144A Clerkenwell Road, EC1R 5DF 2015/0098/P

Delegated Report		Analysis sheet		Expiry Date:	24/03/2015			
(Members Briefing)		N/A / attached		Consultation Expiry Date:	26.2.15			
Officer			Application Number(s)					
Jennifer Chivers			2015/0098/P					
Application Address			Drawing Numbers					
144A Clerkenwell Road London EC1R 5DF			See decision notice					
PO 3/4 Area Tea	am Signature	C&UD	Authorised Officer Signature					
Proposal(s)								
Installation of condenser unit and associated enclosure at roof level of existing office and new riser on west elevation								
Recommendation(s): Grant planning permission								
Application Type: Full Planning Permission								
Conditions or Reasons for Refusal:	Refer to Draft Decision No		otice					
Informatives:

Full Planning Permission Granted

Installation of condenser unit, erection of enclosure at roof level of existing office and new riser on west elevation

Photograph Two: Tank and equipment to be removed from roof level

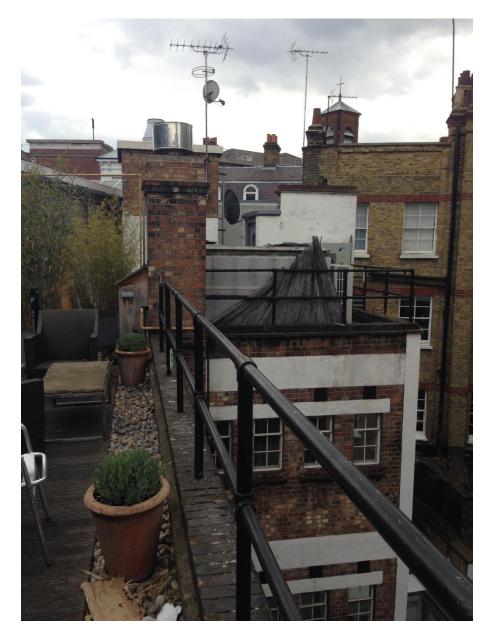
- 3.1 The proposed louvre screen and condenser unit is comparable in size and number to the existing equipment it would replace. Due to the scale and location of the existing equipment and the presence of other plant and machinery in this area, the proposed unit would not appear prominent or out of keeping with the surrounding environment.

- 3.1 Whilst the louvre screen would be visible from White Bear Yard, the screen would not be particularly prominent within Clerkenwell Road given the building's setting. The 1.6 metre screen above the Clerkenwell elevation would not harm the appearance of the host property or the conservation area.
